**DOCKET NUMBER 50-483
CALLAWAY PLANT
UNION ELECTRIC COMPANY
RESPONSE TO REQUEST FOR ADDITIONAL INFORMATION
ON REVISION TO TECHNICAL SPECIFICATION 5.5.9
"STEAM GENERATOR (SG) TUBE SURVEILLANCE PROGRAM"**

**REQUEST FOR ADDITIONAL INFORMATION
REVIEW OF THE CALLAWAY PLANT APPLICATION
FOR REVISION TO TECHNICAL SPECIFICATION 3/4.4
TAC NUMBER: MB1214**

Figure R6-32

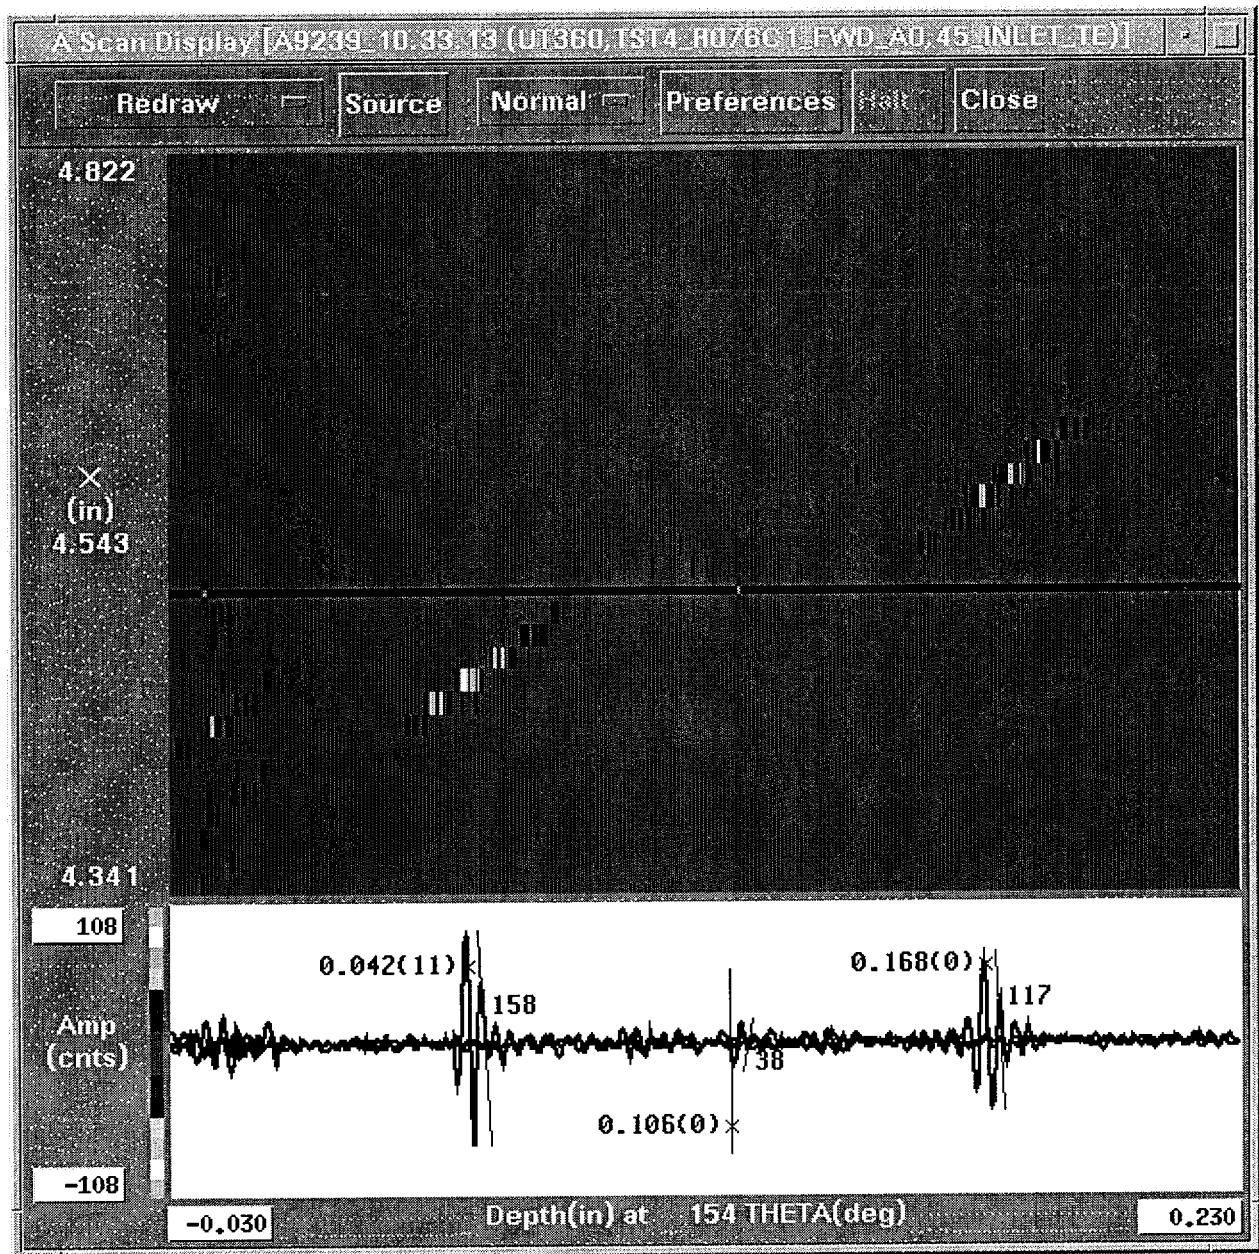
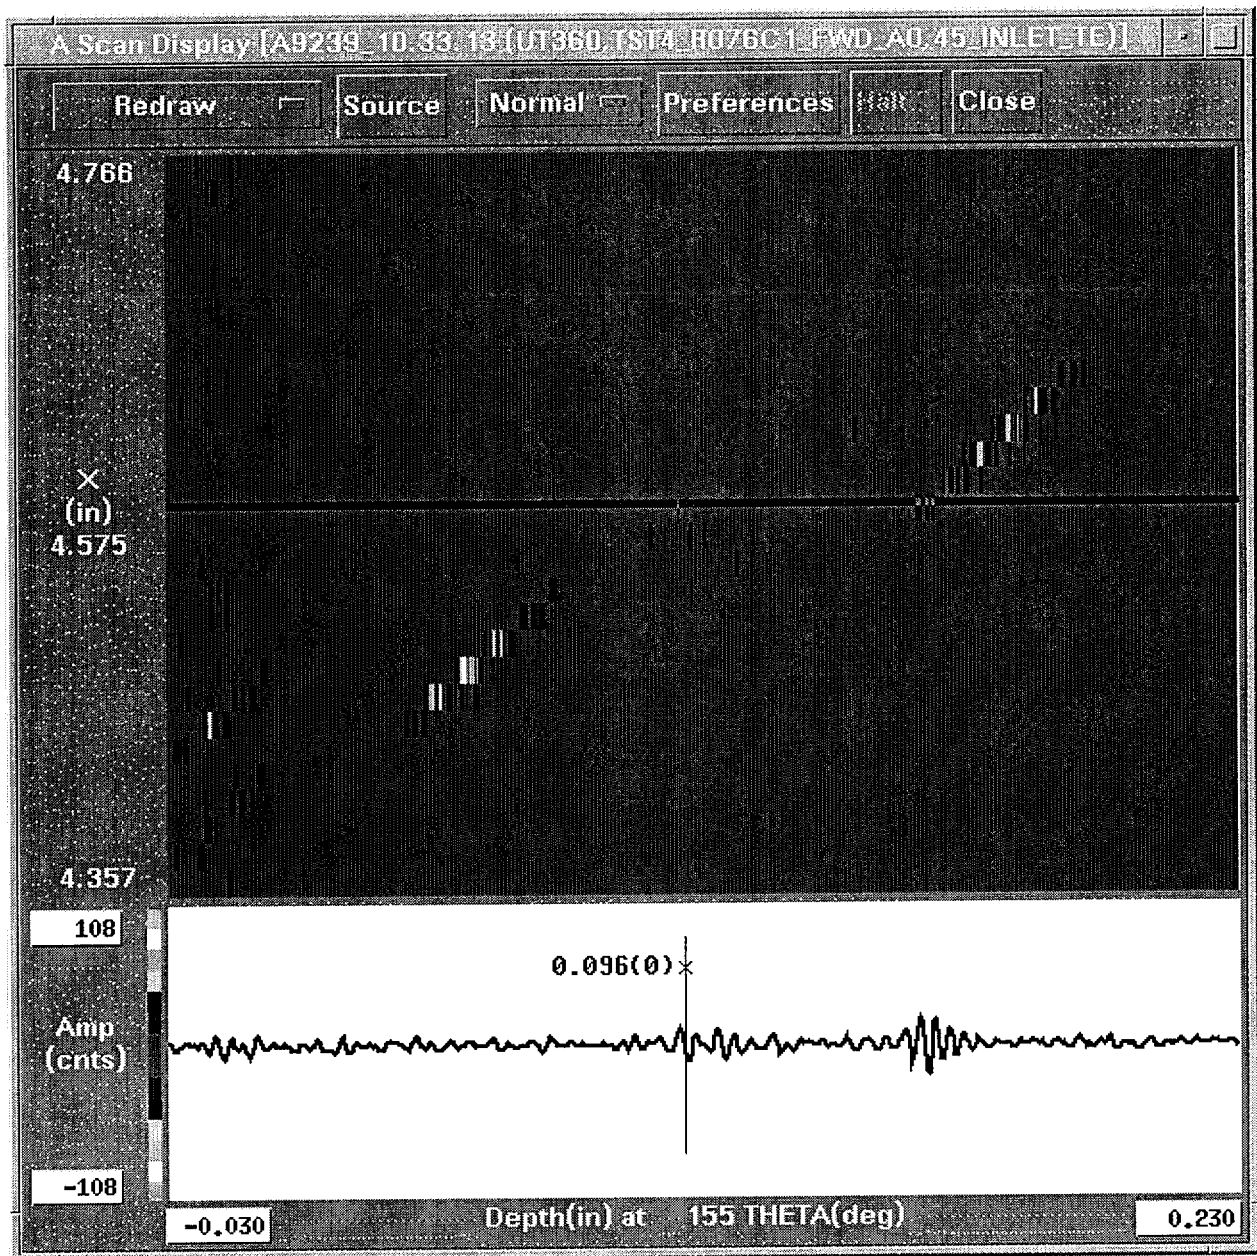
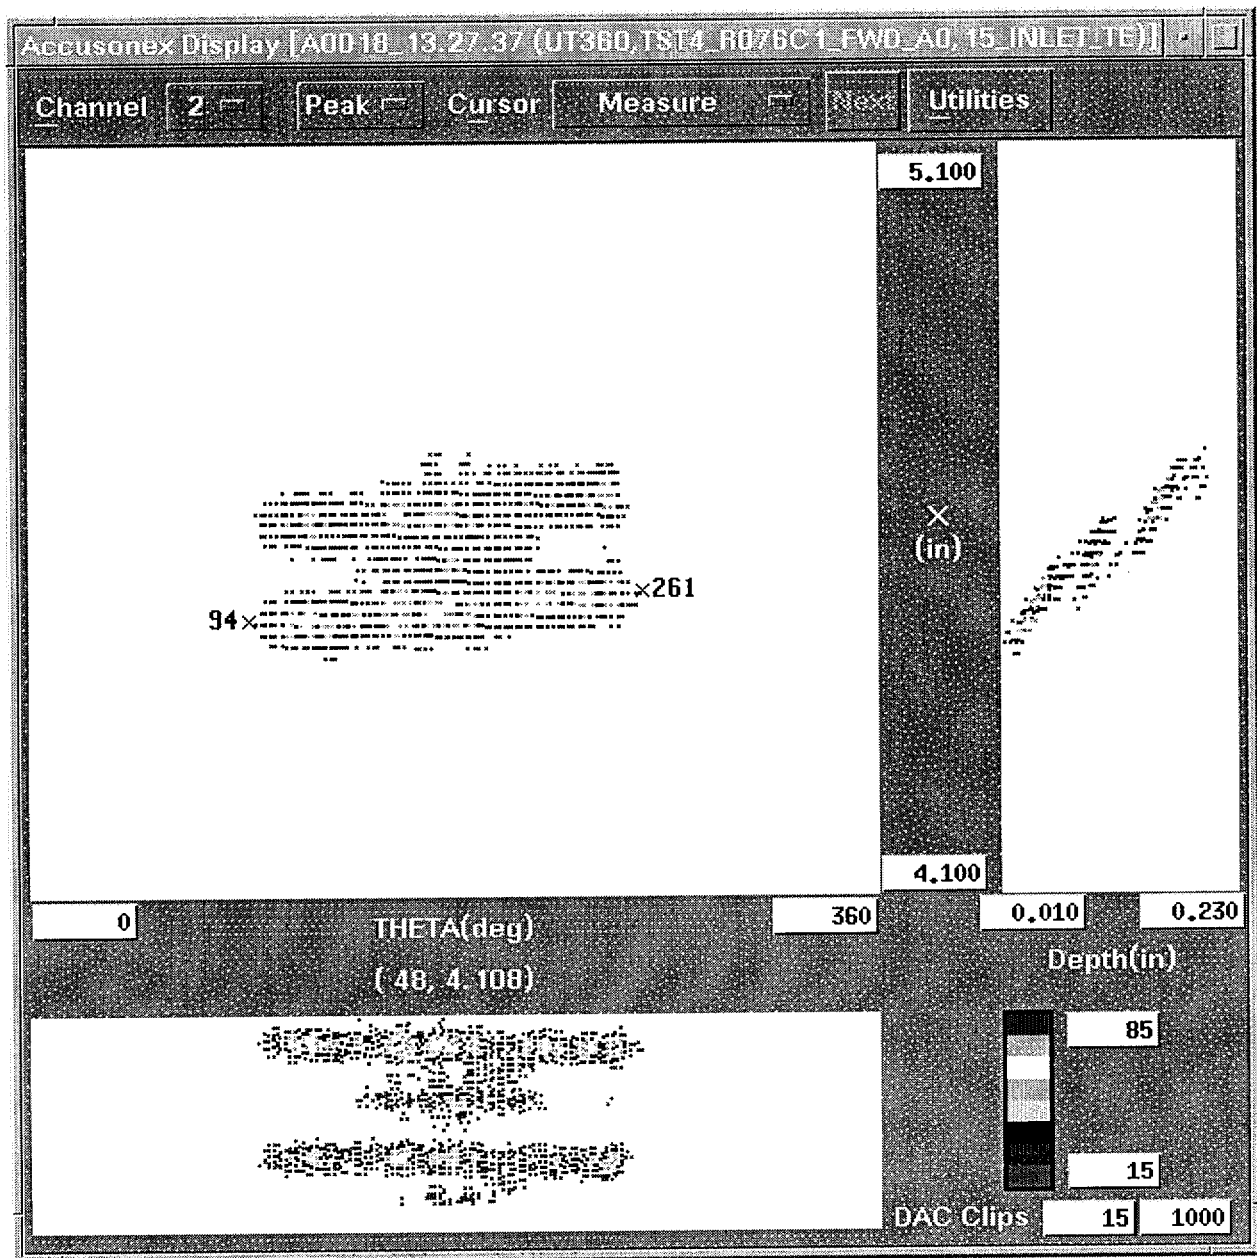
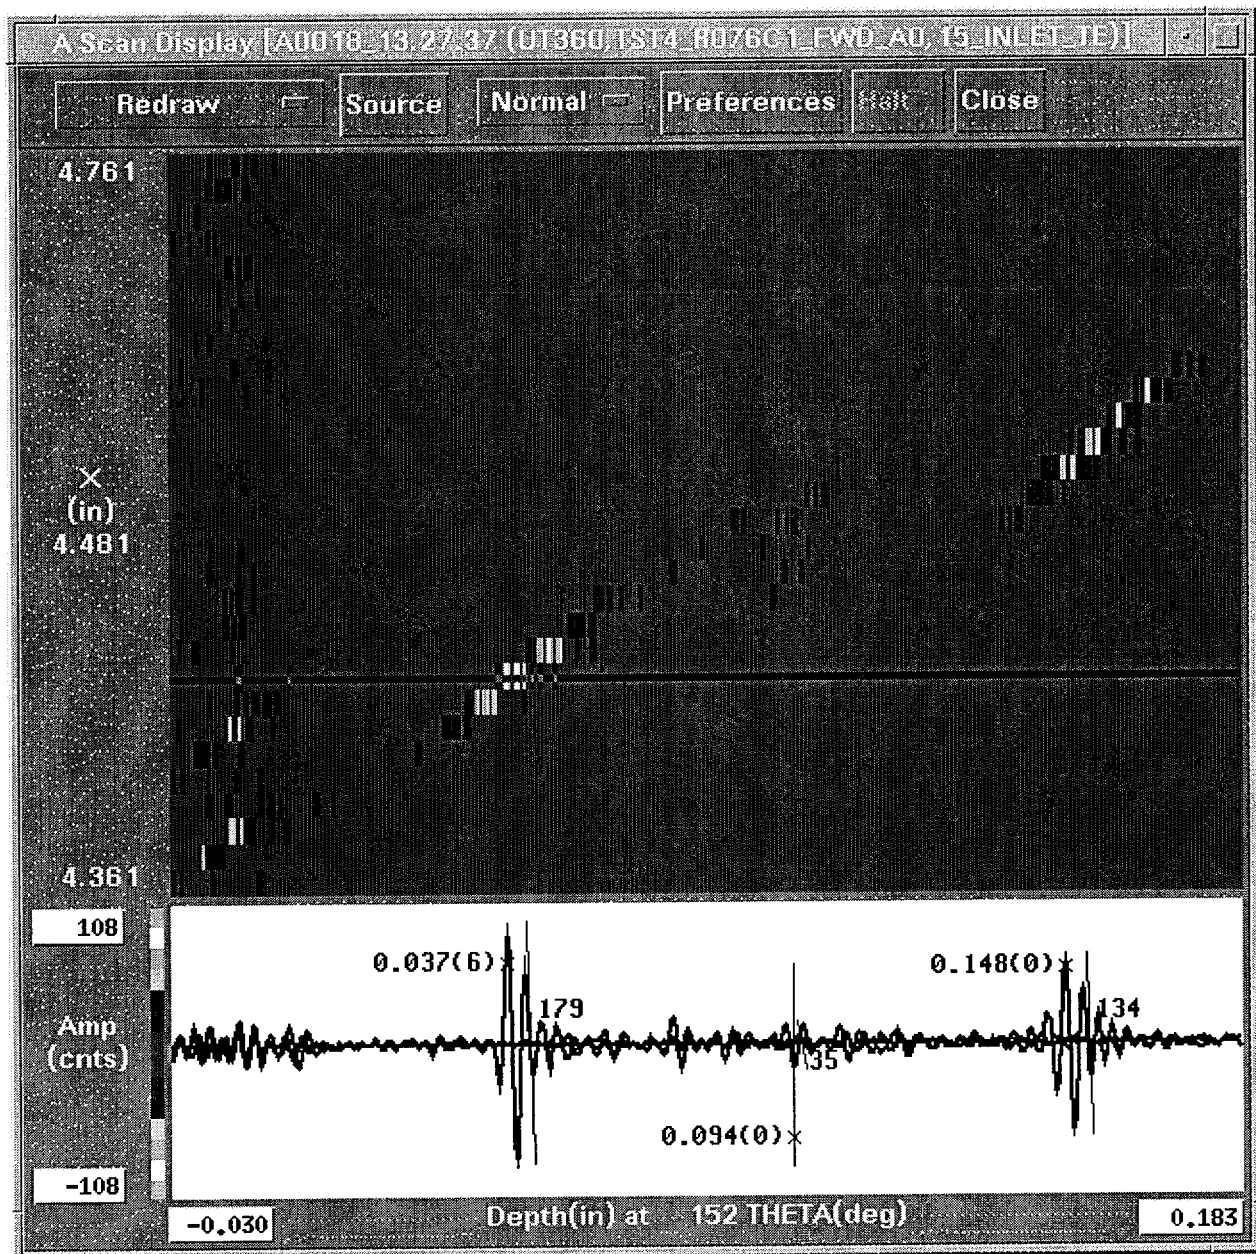
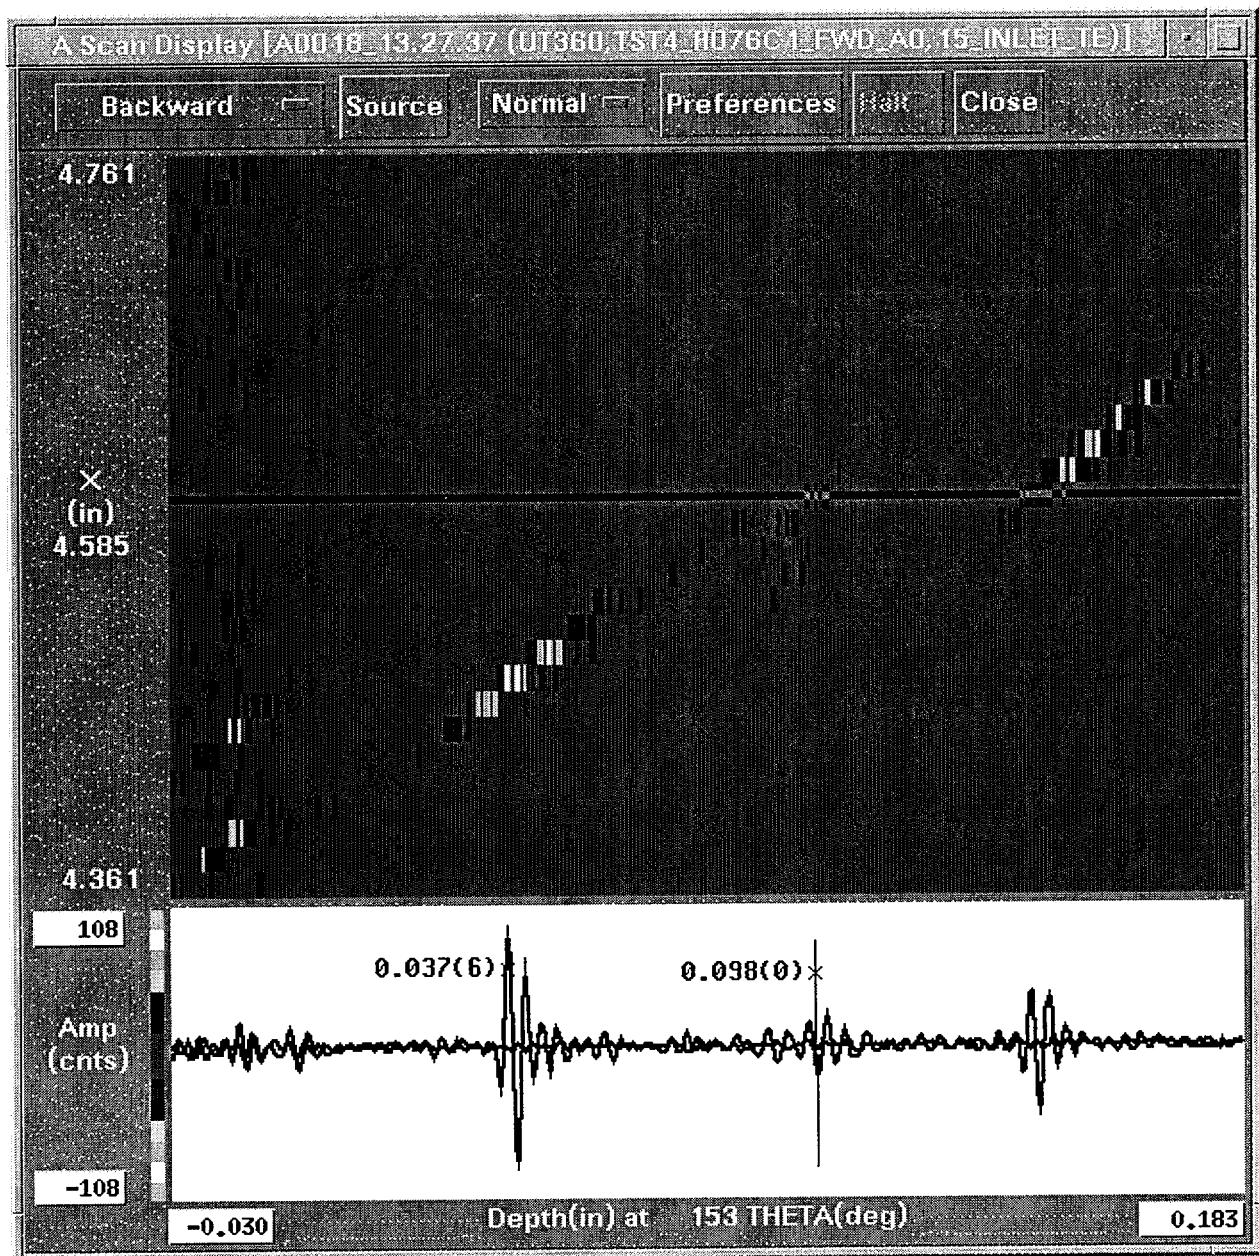
RAI # 6. During the meeting, FTI indicated that PWSCC detectability in the sleeve could be inferred from the ID notches in the UT calibration standards and the data sets containing pits. It is not clear to the staff how detecting EDM notches in the calibration standards or another degradation morphology such as pits would infer an ability to detect tight flaws such as PWSCC. Explain the basis for the statement that sleeve PWSCC ID defects will be detected, and the resulting sensitivity and POD, since the peer review (ETSS # 98404) only covers volumetric defects. Please provide additional discussion or, preferably, additional data to support the claims of the capability of the technique to detect PWSCC in the sleeve. (Question from the 6/7/01 meeting held with UE, FTI, and the NRC staff)

During the fatigue cycling, fatigue cracks developed in the sleeve wall at the inner diameter crack site as well as at the outer diameter crack site. The post fatigue portion of this presentation will show the return of the full skip reflection at the inner diameter crack location as well as the increase in the FSN result for the outer diameter crack.

This is the pre-sleeve C-Scan plot of the ODSCC circumferential crack in tube TST4-076-1. The outer diameter crack extent (length) can be estimated from the C-Scan plot as $(261 - 95)$ or 166 degrees. The plot shows the presence of a half skip response, a one and one half skip response and a considerable amount of full skip and two skip reflections.

This is the post sleeve (pre-fatigue) C-Scan plot of the ODSCC circumferential crack in tube TST4-076-1. The outer diameter crack extent (length) can be estimated from the C-Scan plot as (261– 96) or 165 degrees. The plot shows the presence of a half skip response, a one and one half skip response and some full skip reflections between the 170 degree and 220 degree locations.

This is the post fatigue crack C-Scan plot of the ODSCC circumferential crack in tube TST4-076-1. The crack extent (length) can be estimated from the C-Scan plot as $(261 - 94)$ or 167 degrees. The plot shows the presence of a half skip response, a one and one half skip response and the return of the full skip reflections.
